Attn: Dan Reisman, Planning Board Chair
Re: **129 W. Genesee Street Splash Car Wash – Site Plan Review**

The following letter has been written in response to the review comments from Napierala Consulting dated September 7, 2022, received from the Village of Fayetteville on August 24, 2022. The following comments have been addressed below.

129 W GENESEE STREET SPLASH CAR WASH VILLAGE OF FAYETTEVILLE, ONONDAGA COUNTY, NEW YORK		DRAWING TITLE: TURNING MOVEMENTS	
DRAWN BY: GRS	APPROVED BY: ESM	PROJ. NO.: 72220023	ANSI D
CHECKED BY: CAK	DATE: 6-24-22	PAGE SIZE:

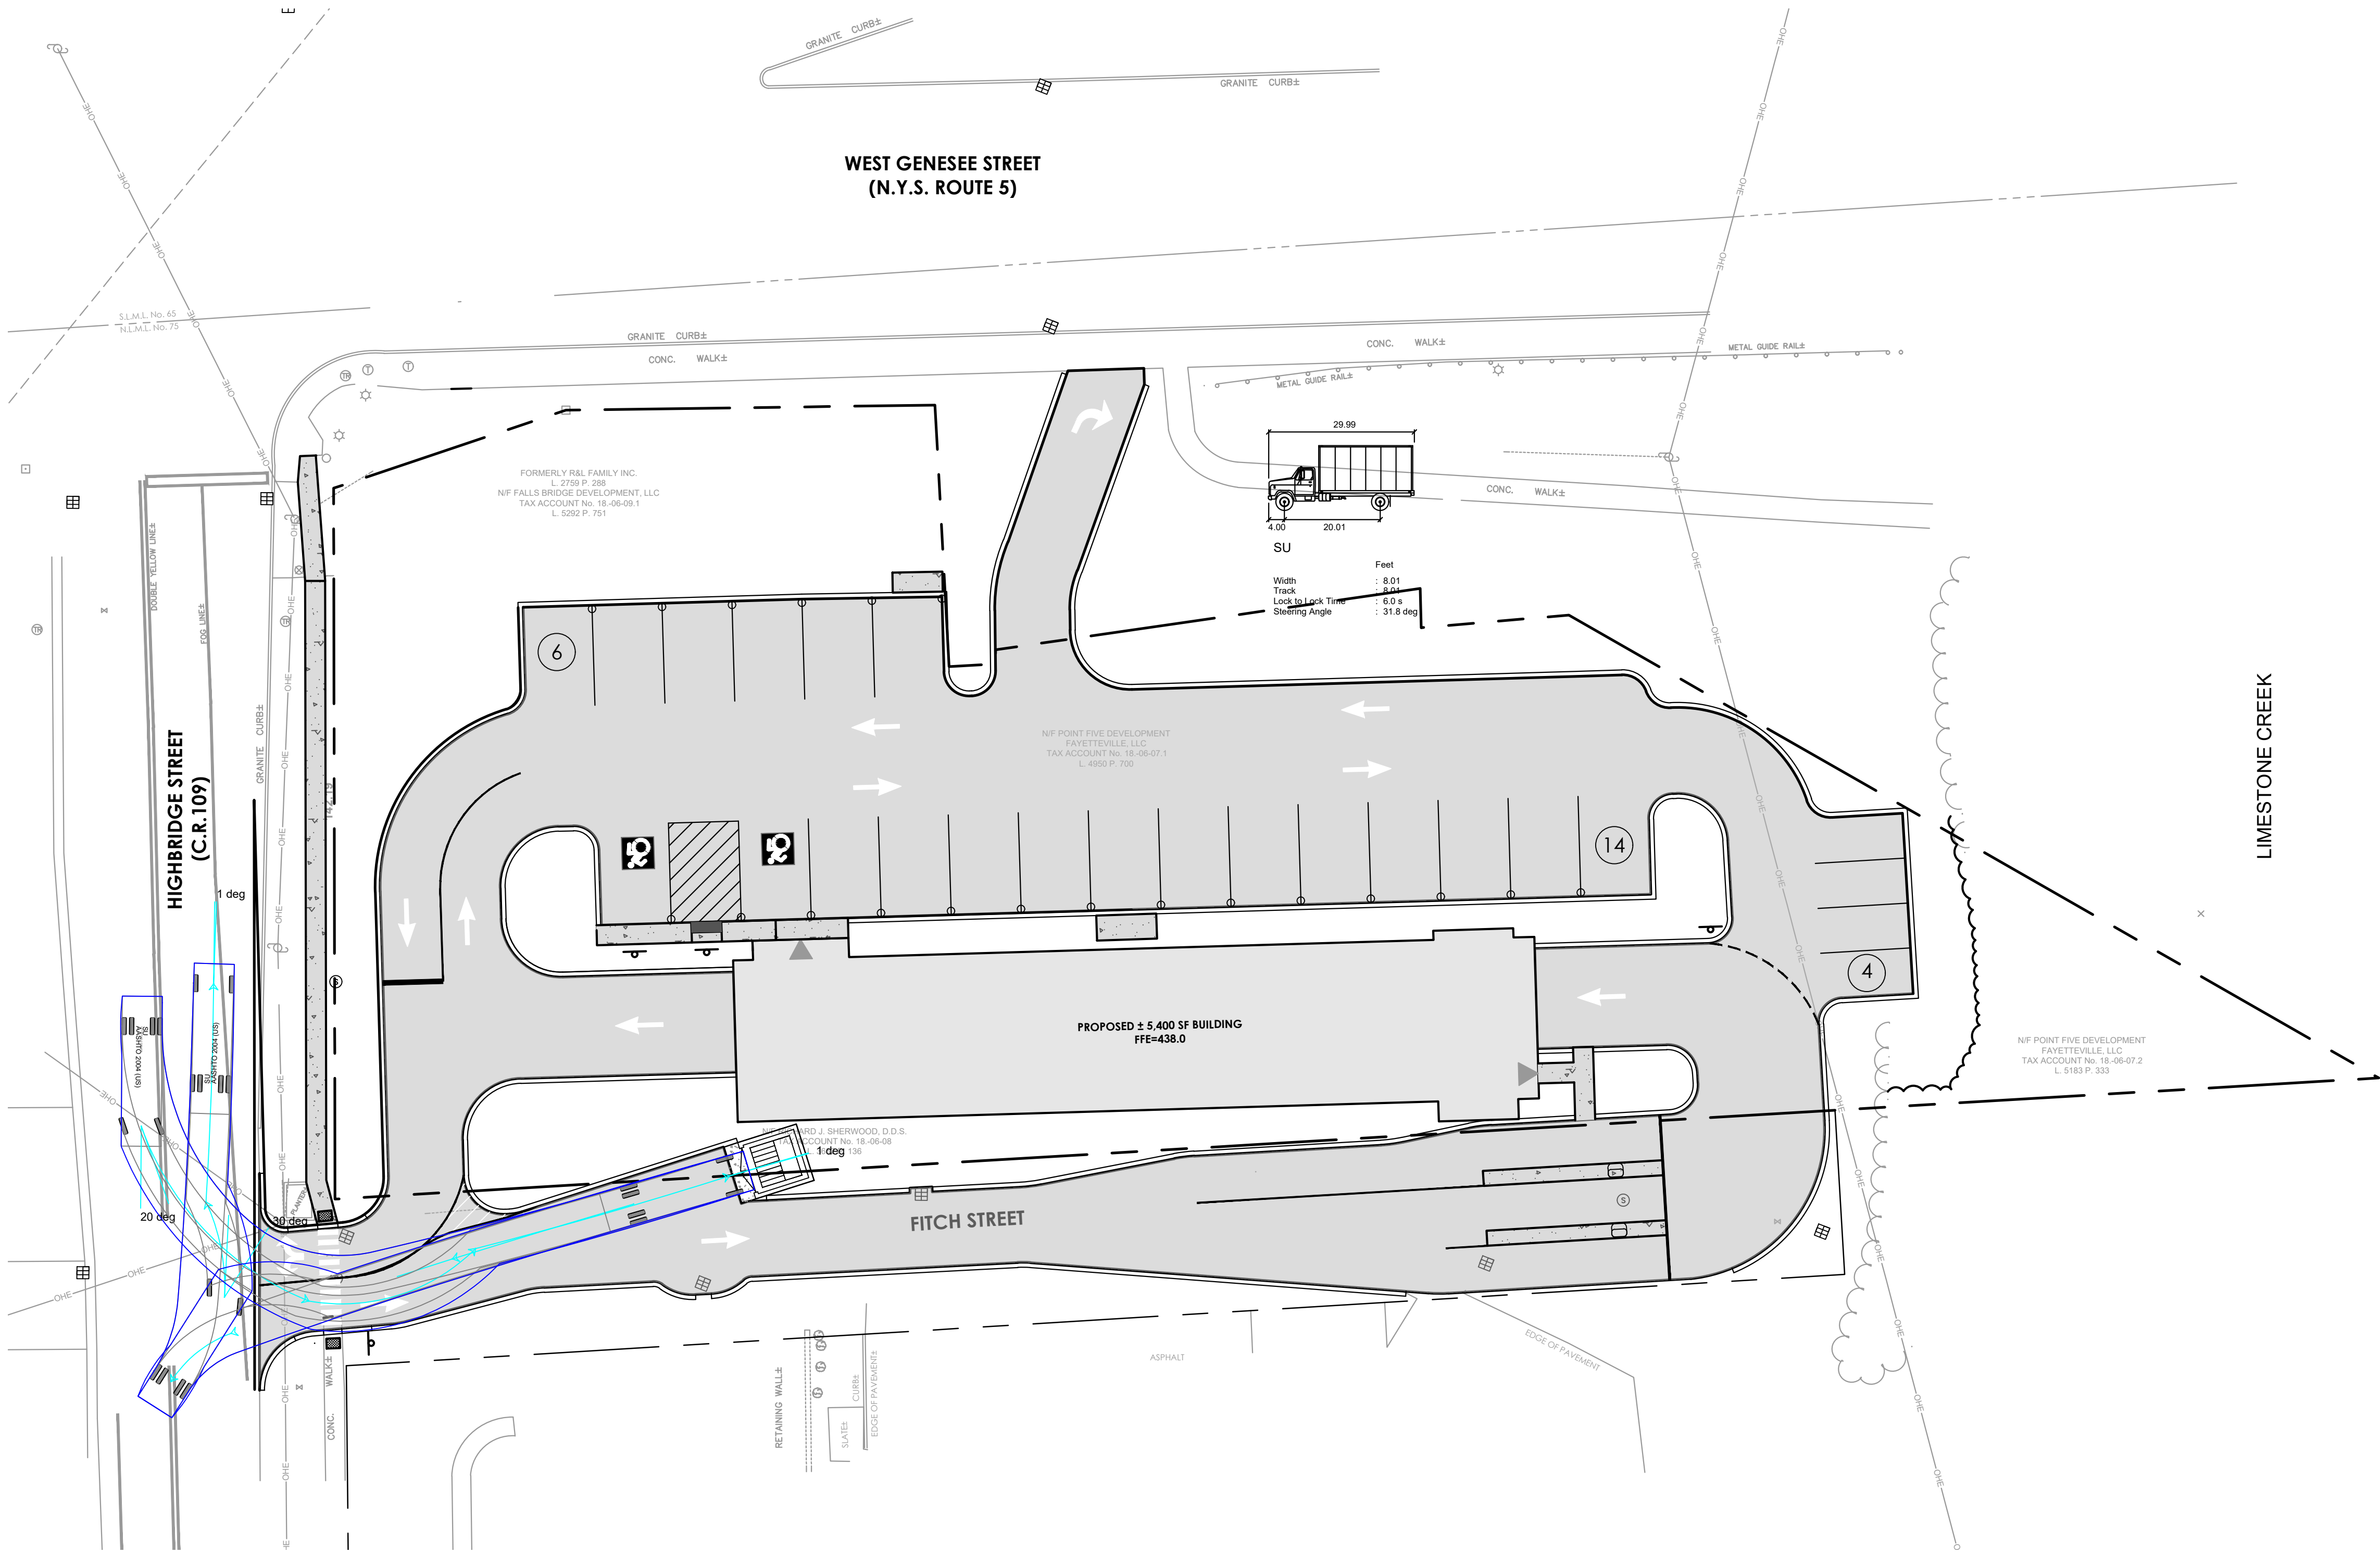
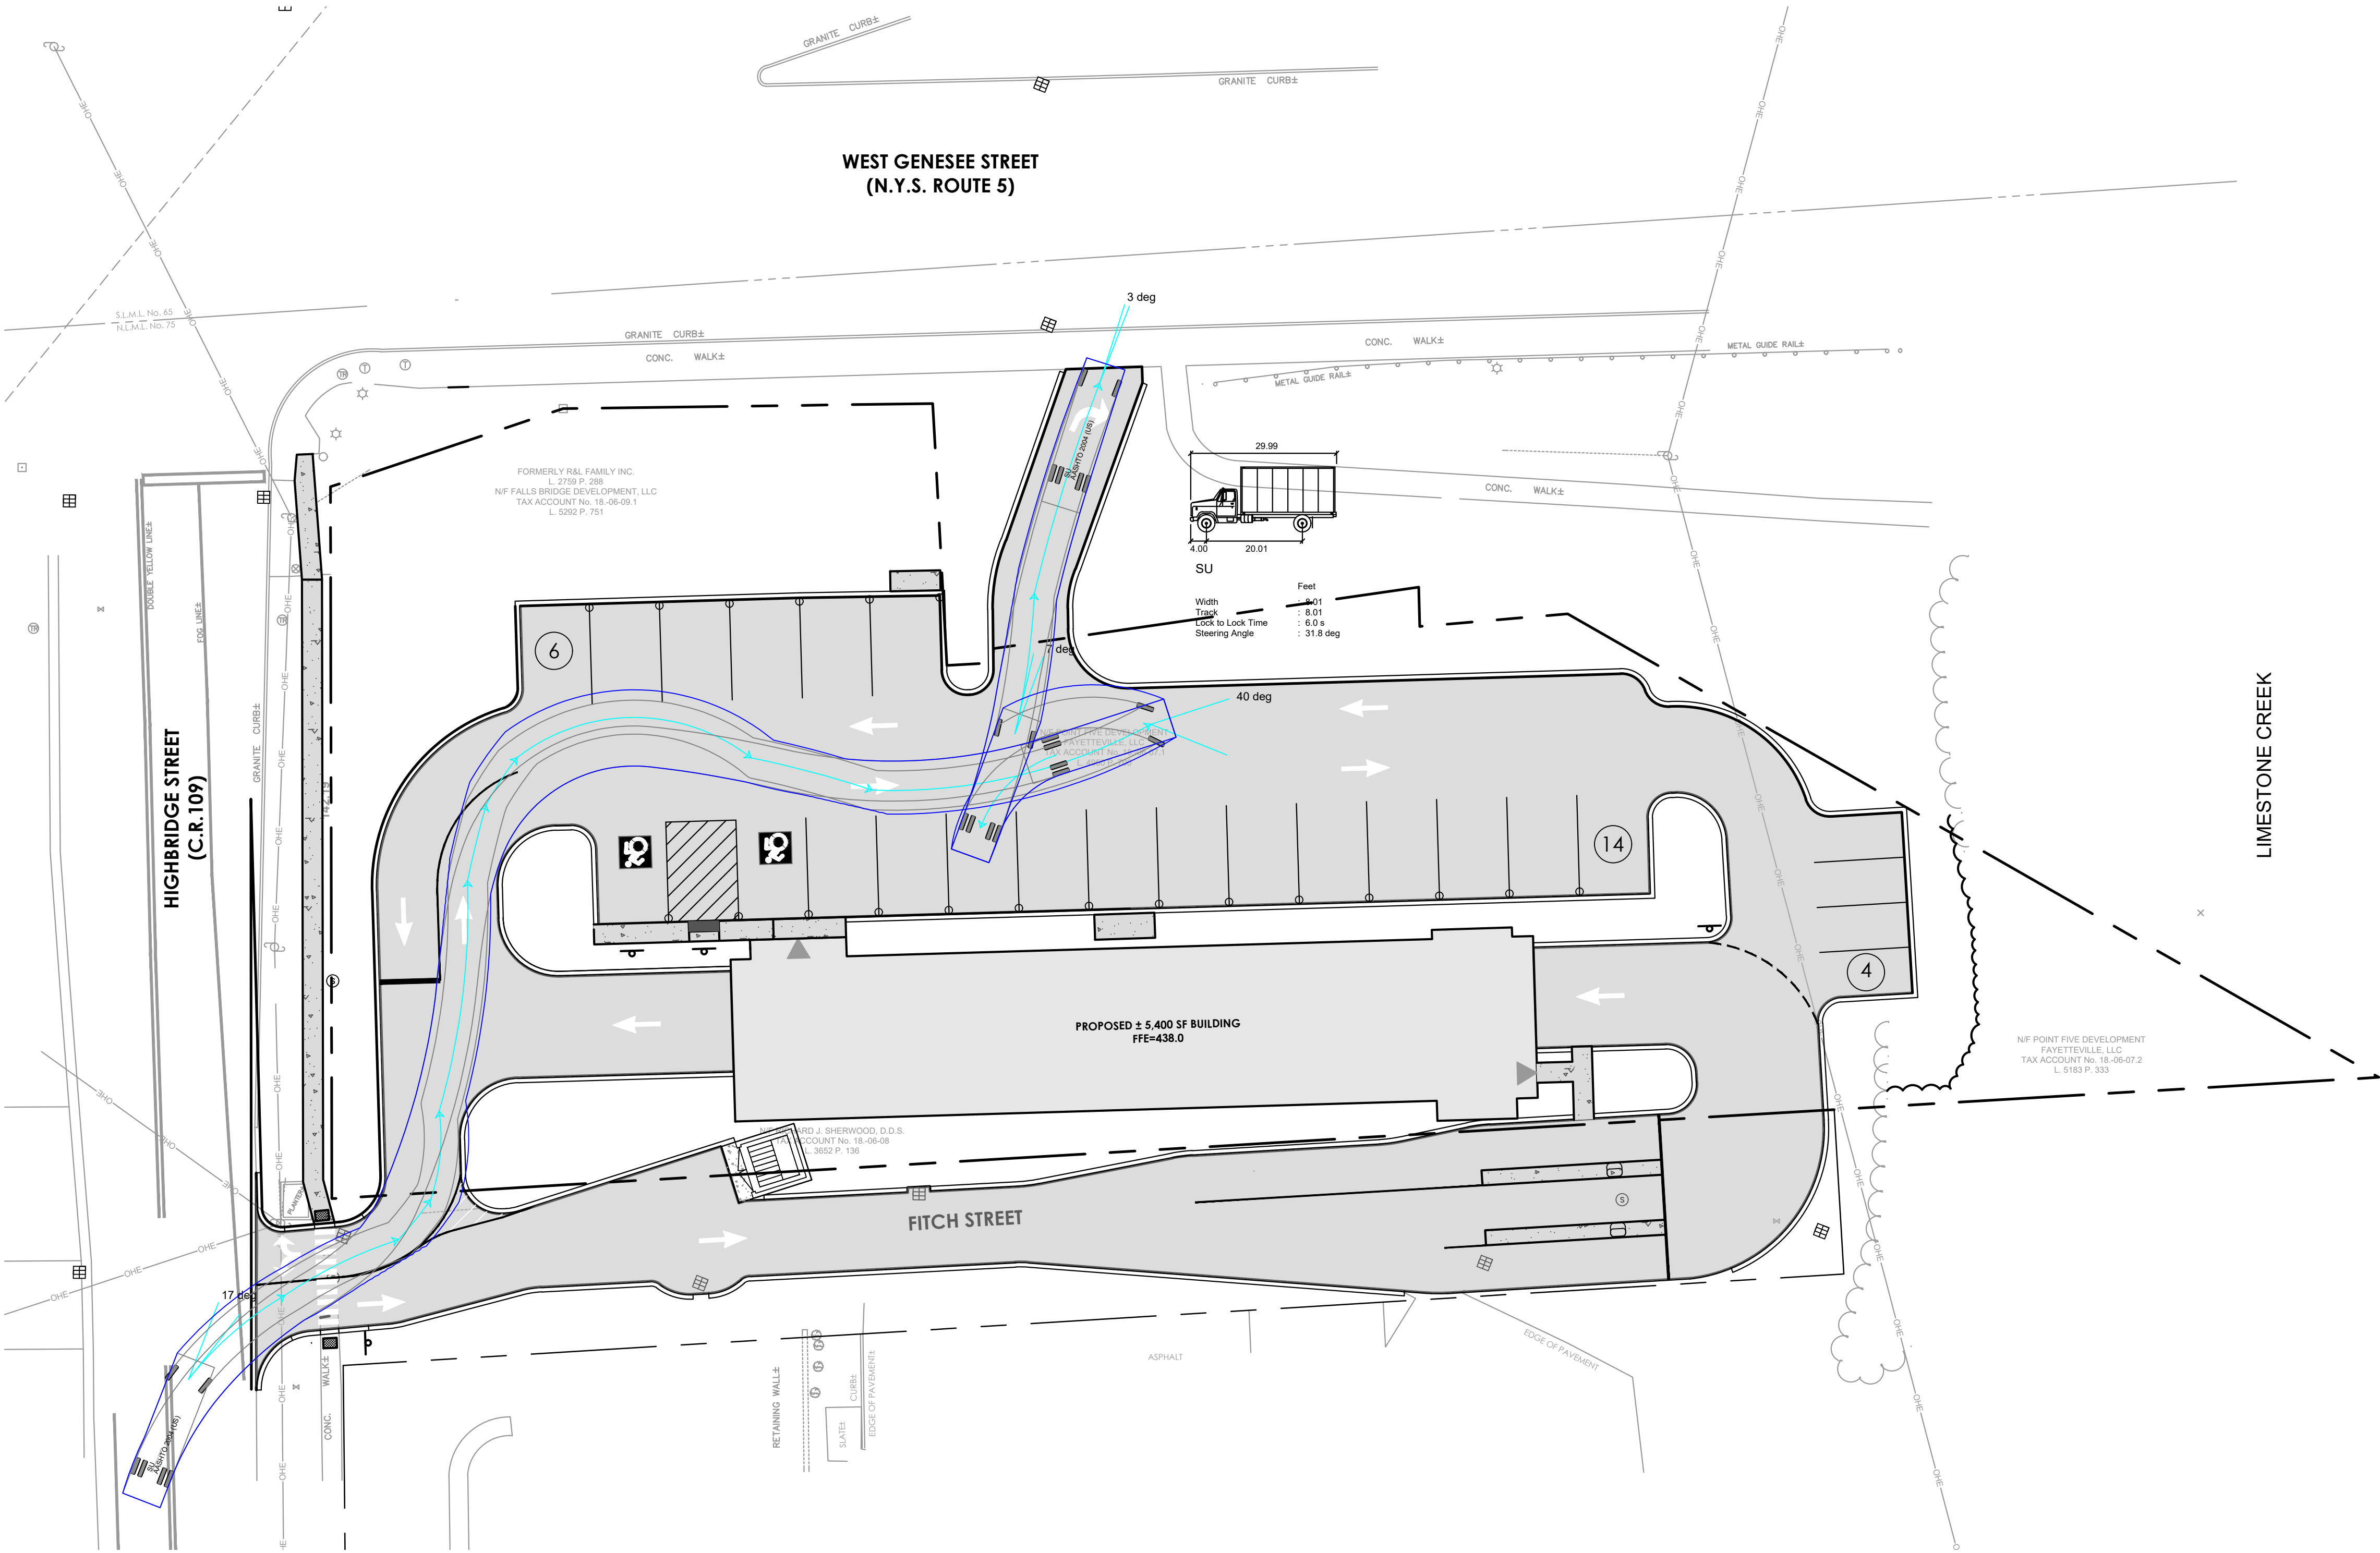
- 1) Site Plan, C3
 - b. Provide delivery/vendor/garbage truck circulation path on the plan for review. Truck movements are integral part of the site plan and required for planning board review.
Please see turning movements sheet included with this submission package.
 - c. Coordinate review of firetruck/EMS access with the Village of Fayetteville Fire Department
Turning movements have been sent to Village of Fayetteville fire department chief for review and approval.
